PLES I GEOTHERMAL DEVELOPMENT PROJECT

FINAL ENVIRONMENTAL IMPACT STATEMENT AND SUPPLEMENTAL ENVIRONMENTAL IMPACT REPORT

June 1989

FIGURE 4-1
 Cross-Section Along Line-of-Sight from
 Highway 395 Near Mammoth Creek to
 Proposed Power Plant Site

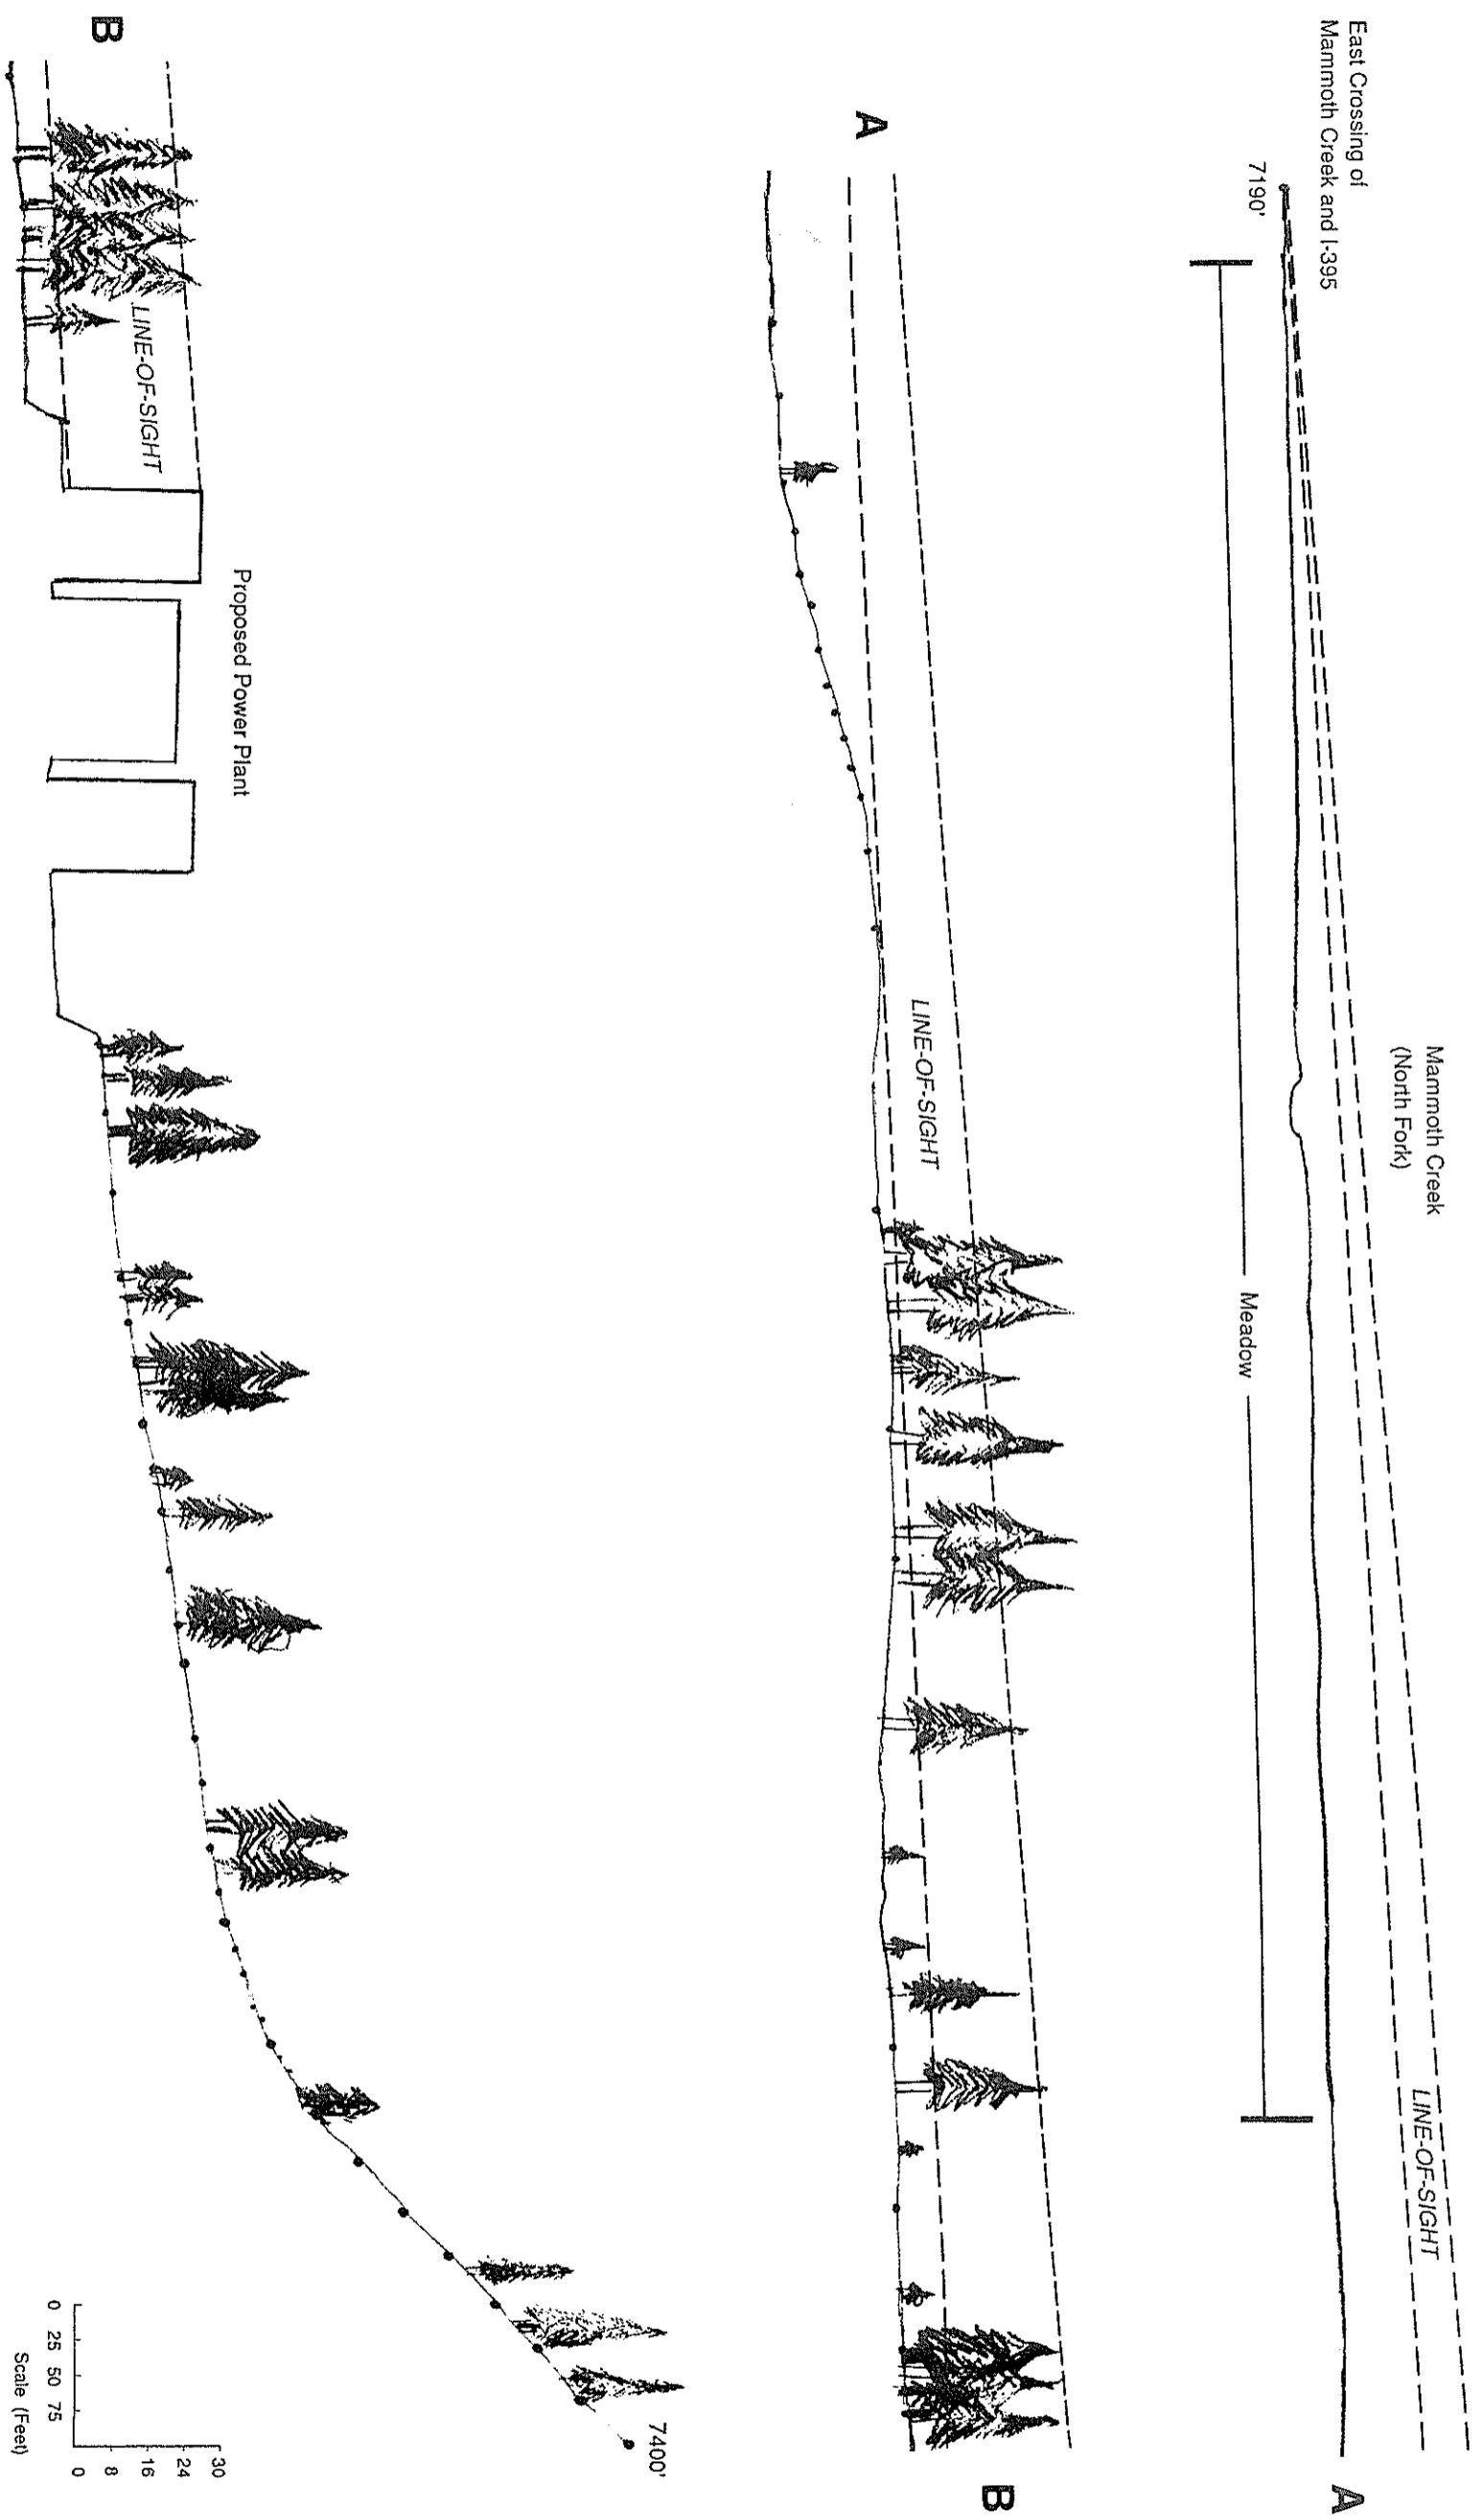
6-52 The extent of the visual analysis seems to be based on the assumption that viewers will be wearing blinders. The Sensitive vantage point used to generate Figure 4-1 is just that, a single point. Not only is it a single point, but it is also the lowest point along Hwy. 395 from which to view the project site. As a result, the impression given in figure 4-1 is very misleading. For instance, the overpass of Hwy. 395 at the intersection of Hwy 203 offers a much more exposed vantage point. In addition, people engaged in recreational activities on foot on the thousands of acres of surrounding forest service lands will have an unobstructed view of the project site. (see our scoping comments page 12)

FIGURE 1-12

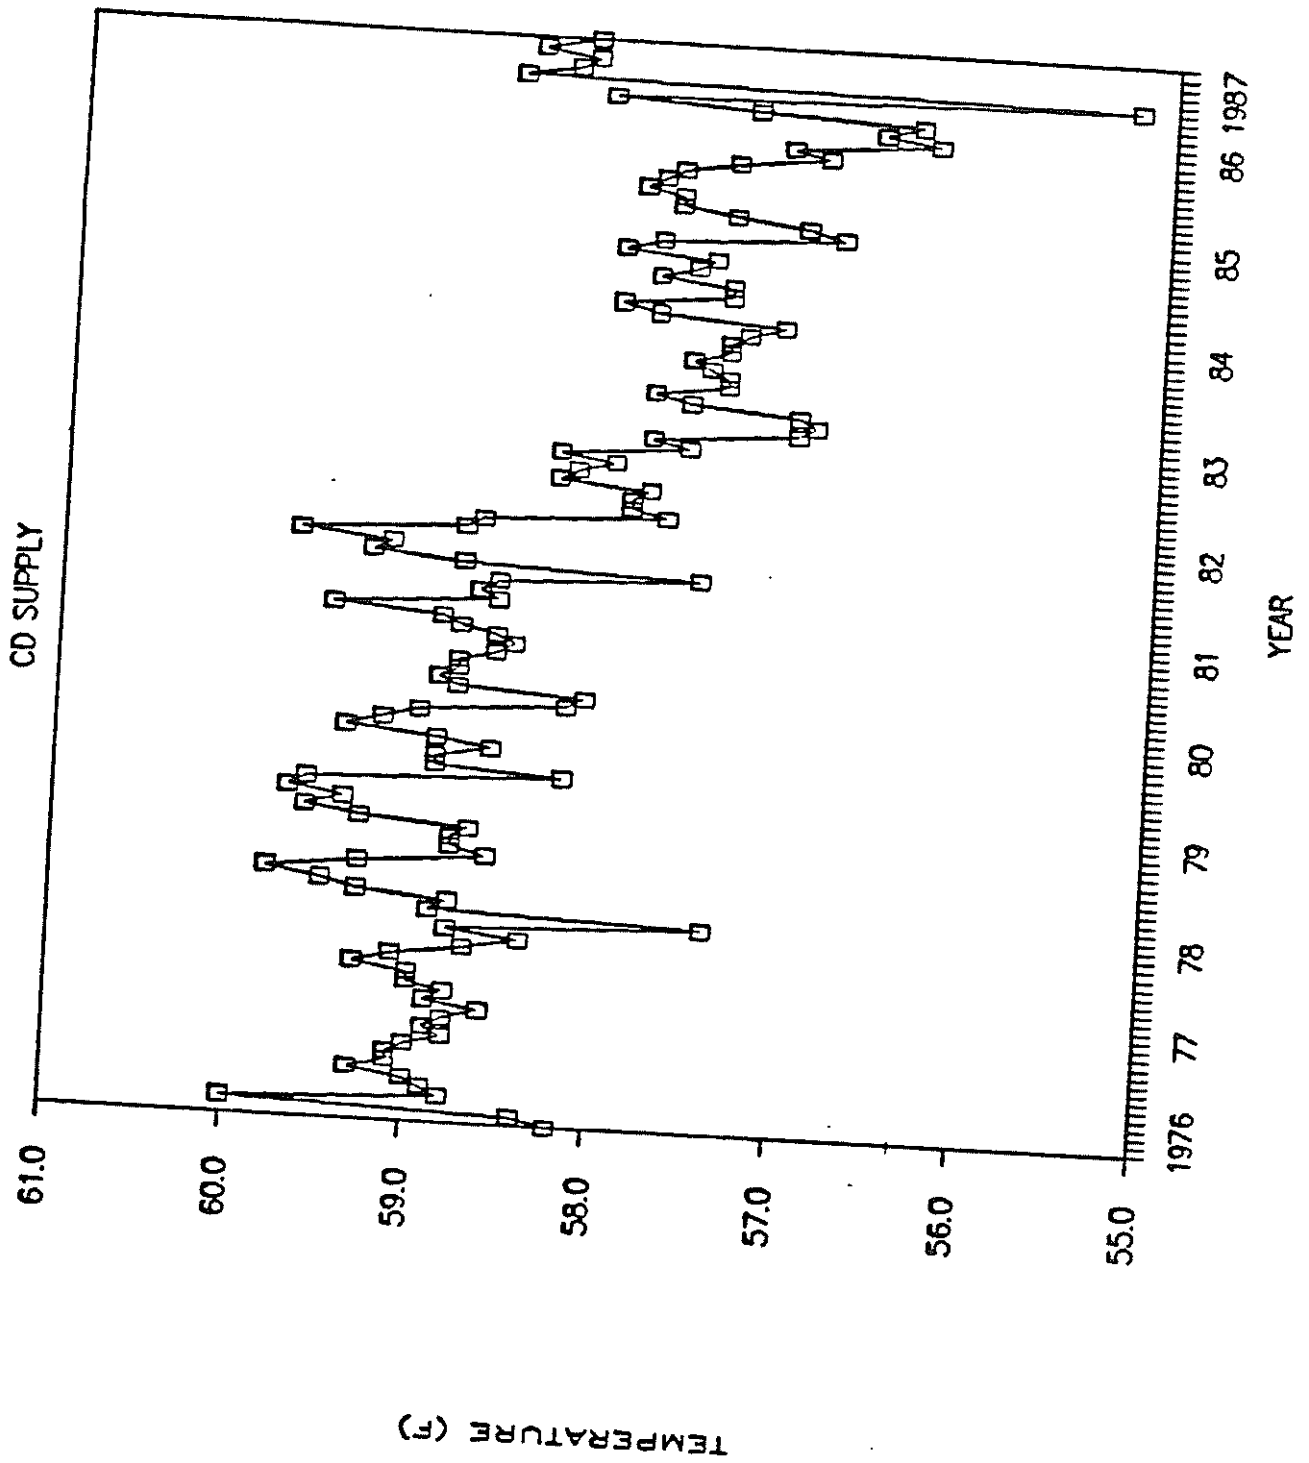
- 3-28/¶ 3 Figure 1-12 (Appendix C) indicates the temperature of the H-1 spring is 53°F, not 54°F, and that the range is from 52.5°F to 56°F, not 51°F to 54°F.
